# REPORT TO PLANNING COMMISSION

**APPLICATION NUMBER:** 2019-25

**APPLICATION NAME:** CHASE BANK

**APPLICANT'S REQUEST:** The applicant is seeking review and approval of a Commercial Site Plan for a proposed walk-up ATM.

**FIGURE 1: FRONT ELEVATION OF PROPOSED WALK-UP ATM**

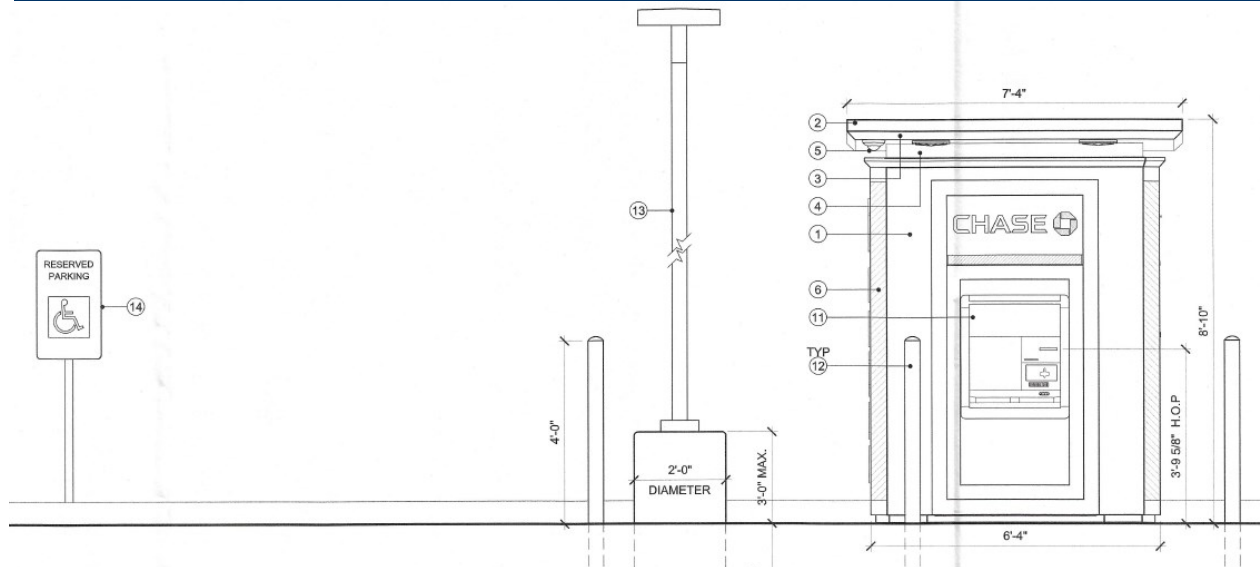
The proposed ATM does not involve major alterations to the site. Besides the construction of the ATM itself, an additional light standard will be installed, six bollards will be placed around the ATM enclosure and light standard, and parking lines will be re-stripped. Figure 1 shows a sketch of the front elevation. The ATM enclosure is a painted metal structure for security purposes; colors are indicated as Chase Nickel Gloss finish with Chase Blue Semi-Gloss and Chase Dark Nickel canopy bevel and collar. There are colored illustrations of the elevations provided in the Exhibit A.

**FIGURE 2: EXISTING (BLUE) AND PROPOSED (RED) LIGHT POLE LOCATIONS**

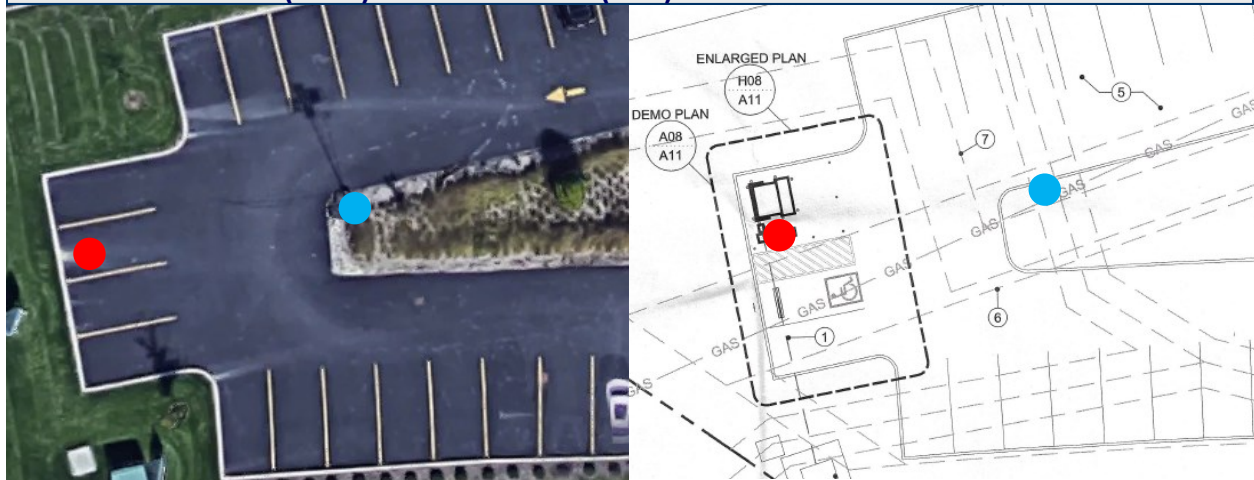
Staff found a potential conflict in the proposed light standard, specifically with its location. See Figure 2, which shows the location of an existing light pole (25 ft. in height) and proposed light pole (15 ft. in height) on both a satellite image and the proposed site plan. The Lighting standards of the "C-4" District document for this property states a minimum 100 foot pole spacing standard. The proposed location of the new light pole is shown to be approximately 53 feet from an existing light pole located in the center landscaping area of the parking lot. The "C-4" District document also states alternative separation distances can be submitted and approved by Staff. Due to the fact that the ATM will be serving pedestrians or people outside of their cars, Staff finds that the smaller, pedestrian-scale 15 ft. light standard at this location would serve as a security light for pedestrian safety.
